UNITED STATES PATENT AND TRADEMARK OFFICE

Office Action Summary	Application No. 10/533,990	Applicant(s) WUNDERLICH, ANDREAS	
	Examiner Katherine W. Mitchell	Art Unit 3677

DETAILED ACTION

EP 0 501 860 A1

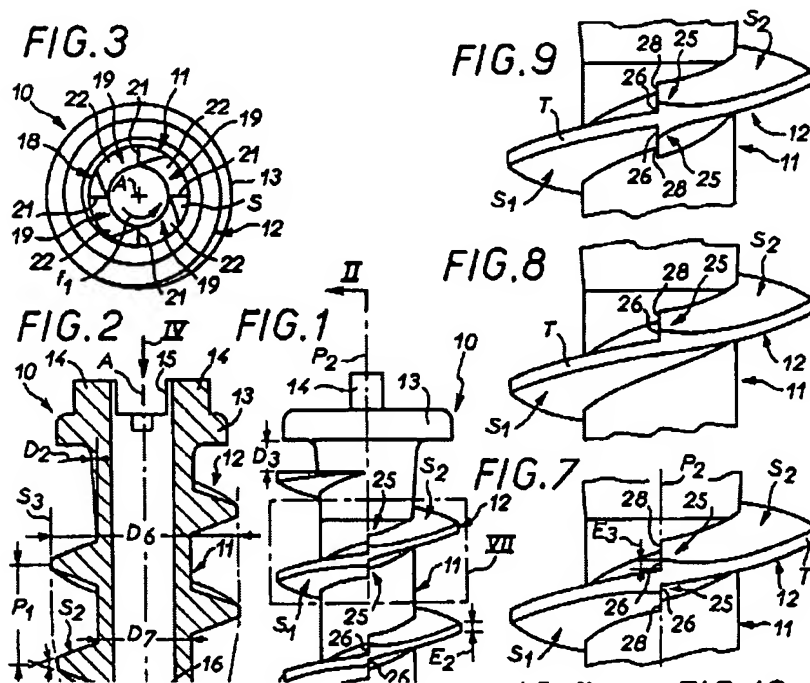
11. As best understood, claims 1-9 and 13-14 are rejected under 35 U.S.C. 102(b) as being anticipated by Auger, EP 0501860.

Examiner is very unsure of what is being claimed, but as best understood, Auger teaches in the Figures and abstract a screw capable for use on hard materials, with a shaft, head at one end, tip, and a thread with cutting teeth having equal but opposite sides that are laterally offset to opposite sides of the thread's longitudinal centerline. (see new matter above). There are a series of cutting teeth formed along at least one half turn of the thread—the series is formed by considering multiple half turns to include multiple teeth. As best understood, noting that paragraph [0008] is the only disclosure of a sawtooth, examiner considers Auger Fig 1 to be a sawtooth profile, with teeth disposed to opposite sides of the longitudinal centerline (see new matter above). The thread has a flattened crest forming a narrow face (T) with edges 28 extending across it, and there are a plurality of narrow faces along at least one half turn – the plurality is along several turns, which are at least one half turn, and there are cutting edges. The transverse leading edges on at least one side are roughly radially disposed and extend all the way down to the shaft (Fig 10, and Fig 6, not copied, best shows this). The thread has 2 sides with alternating protrusions and notches (Figures, esp. 8,5,10) The teeth are along a longitudinal centerline of the thread and have leading edges as described, and the figures show cutting teeth edges disposed along radii all the way down to the screw shaft. (Figures). The included angle between sides S1 and S2 of the thread are in a range of 20-30 degrees at the portion due to penetrate the drilled hole wall. The included angle between sides S1 and S2 of the thread are in a

range of 45 to 60 degrees over the transition zone immediately adjoining the shaft. Fig 7 and 8 show the teeth (on upper vs lower sides) offset from one another by the width of their face. The set of teeth vary over the shaft length- some are on one side, some are on the other, some have "double" teeth (fig 9 and 7), which is varied.
